Section 2.0 - Specification for Abatement and Selective Demolition Amendment

Amendment #1

PROJECT:
130 CEDAR STREET HOTEL
BUILDING RENOVATION & ADDITION
130 CEDAR STREET, NEW YORK, NY

SKETCH DESCRIPTION:
FDNY LOGISTICS PLAN
GROUND FLOOR

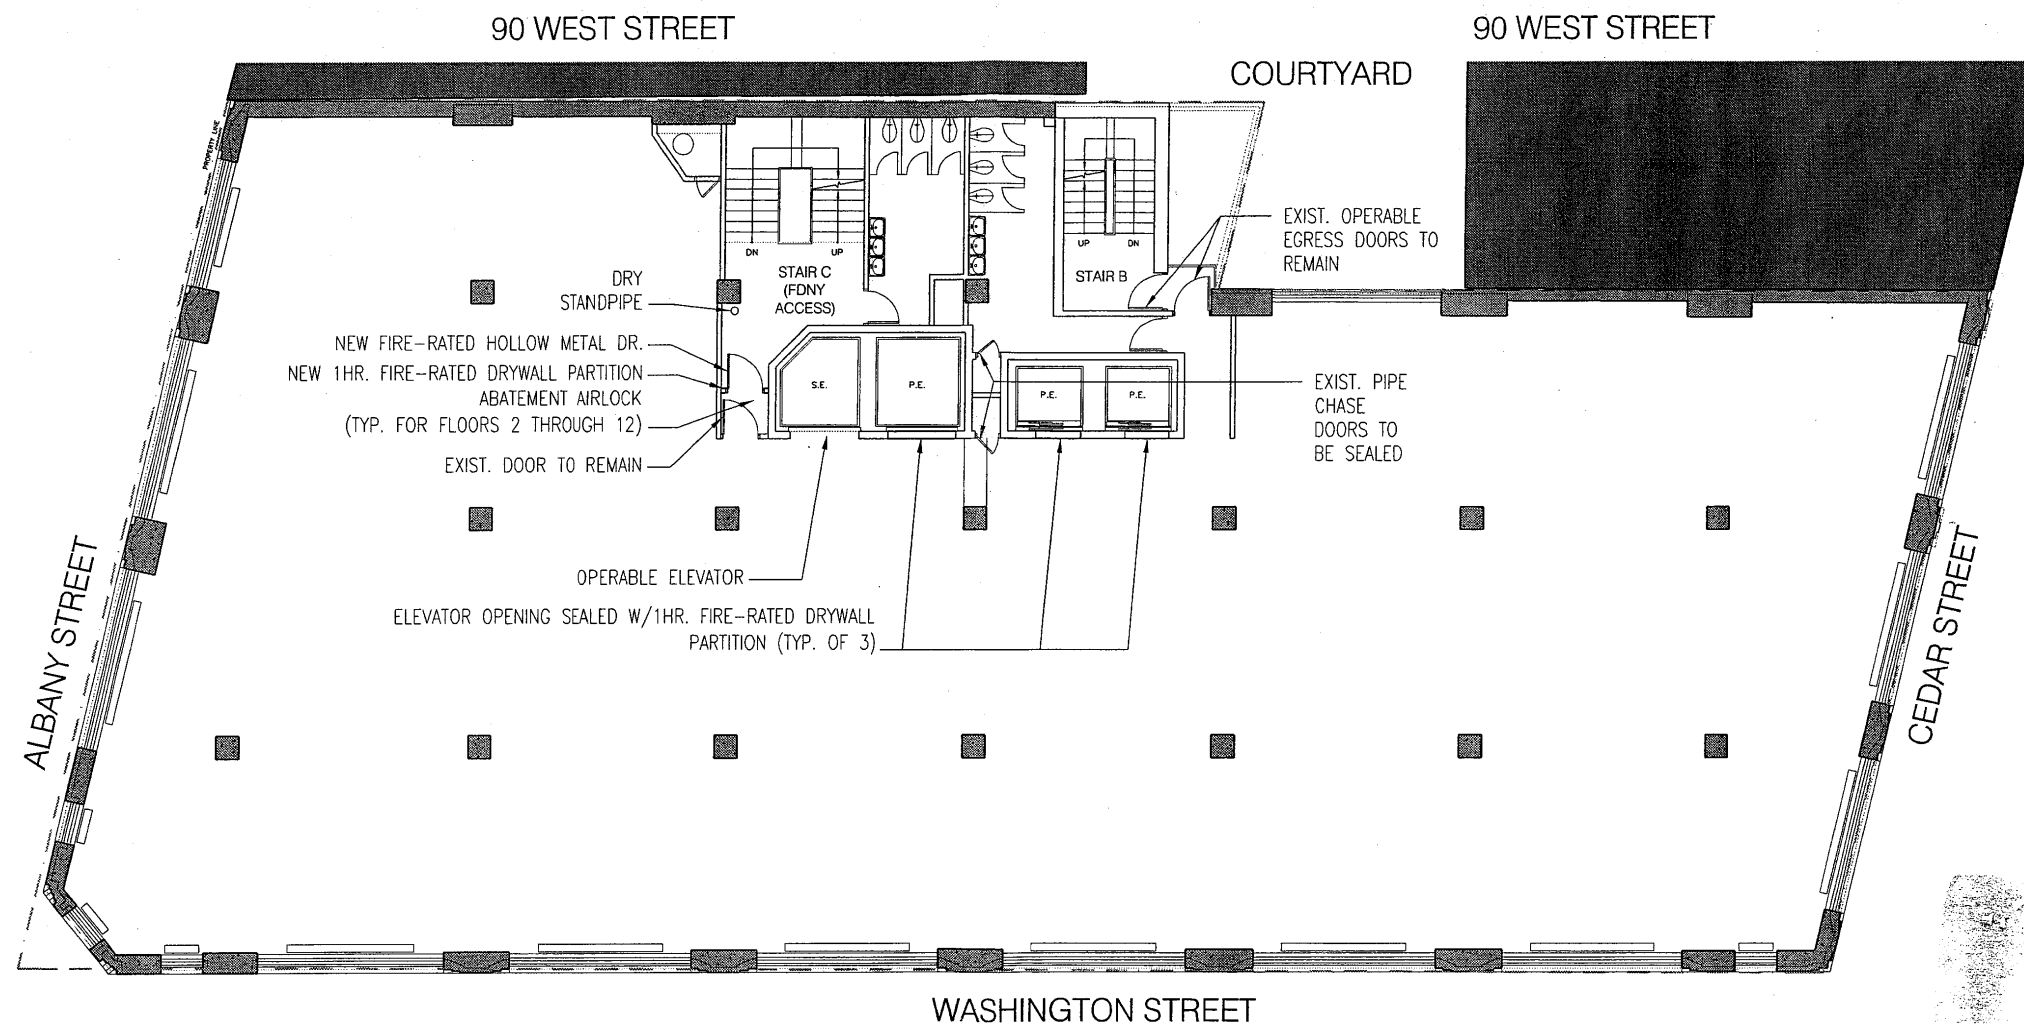
- 1.0 Per the approved plan, hard walled personnel and waste decontamination units per New York City Department of Environmental Protection variance Attachment DI were erected at the east main door access to the 1st floor. The FDNY has required that these units be covered in 2 layers of sheetrock. The sections(s) of the plan affected are;

1. FIRE DEPARTMENT ACCESS THROUGH LOADING DOCK ON ALBANY STREET.
2. STANDPIPE LOCATED IN STAIR C
3. NON-EMERGENCY ACCESS THROUGH WASTE DECON FROM WASHINGTON STREET.

1. PHASE 1 ABATEMENT SHALL LAST APPROX. 6 WEEKS FROM START OF ABATEMENT.
2. DECON CHAMBERS & CLEAN AREAS TO BE RECONFIGURED IN PHASE 2. A SEPARATE SKETCH SHALL BE SUBMITTED FOR FDNY APPROVAL PRIOR TO COMMENCEMENT OF PHASE 2 ABATEMENT.
